CUY-90-14.90

APPENDIX EC-08

**USCG Coordination Information
(Contract Document)**

**Innerbelt Bridge
Construction Contract Group 1 (CCG1)**

PROPOSED VIADUCT
over the Cuyahoga River
at Cleveland
County of Cuyahoga State of Ohio
Application by State Highway Director
Sheet 2 of 2

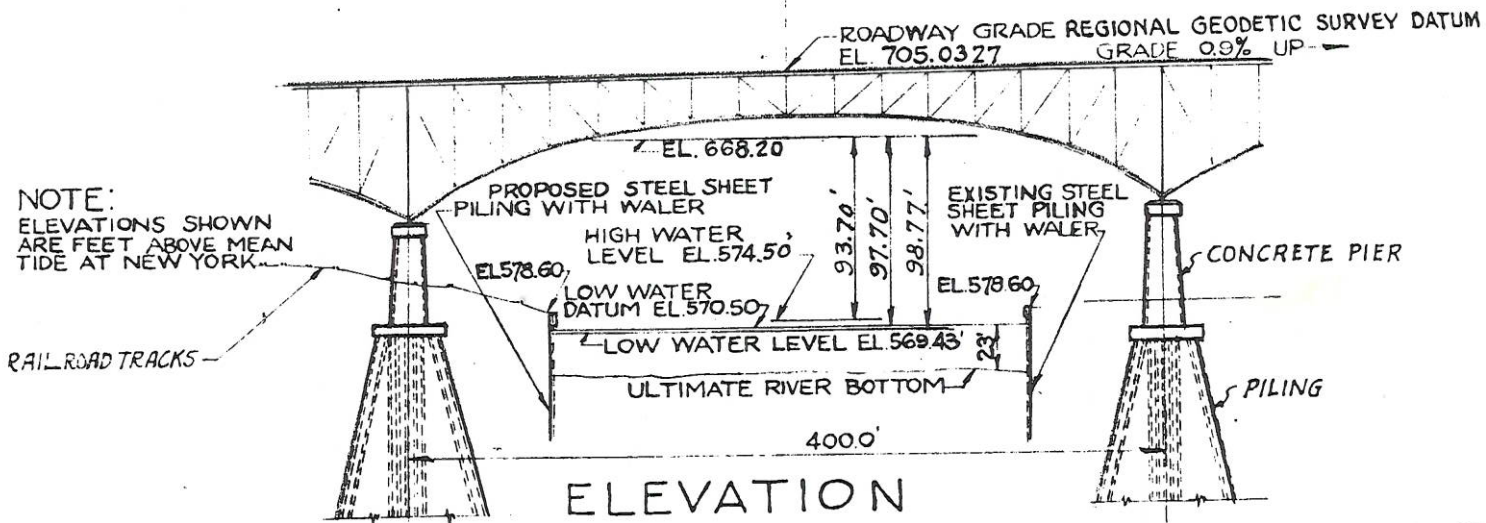
IGLD85 for Low Water Datum for Lake Erie is 569.2 feet. The elevation that was used for Low Water Datum at the time the existing bridge was built was 570.50 feet. I've scanned and attached the drawings we have on file for the existing bridge to help illustrate.

The short answer to your second question is; yes, the lights on the existing bridge indicate the center of the channel, channel edges, and the minimum clearance at the lowest point over the channel (200-foot horizontal and 97.7 feet vertical - referred to the Low Water Datum used at the time. With the revised Low Water Datum elevation of 569.2 feet, the vertical clearance is 99.0 feet at the lowest point over the channel.).

The minimum vertical clearance on the existing bridge is shown as 97.70 feet to Low Water Datum elevation of 570.5 feet. Our earlier correspondence outlines maintaining, at a minimum, the existing clearances. The Final EIS states that at least 100 feet vertical clearance will be provided for any additional or replacement bridges over the Cuyahoga River. That translates to 100 feet of vertical clearance from Low Water Datum for Lake Erie, IGLD85, elevation 569.2 feet. This is the minimum clearance we would accept. All of the conceptual drawings we've seen so far call for a new/replacement structure that has no arch in the span over the river. That design should provide even greater vertical clearance over the river.

As I stated in my email on August 7, 2009, the 100 feet vertical clearance must be provided for the full 200-foot horizontal clearance in the channel, with no piers in the river. Providing greater vertical clearance with a non-arch type structure is even better, and any design-build drawings submitted must satisfy these minimum requirements.
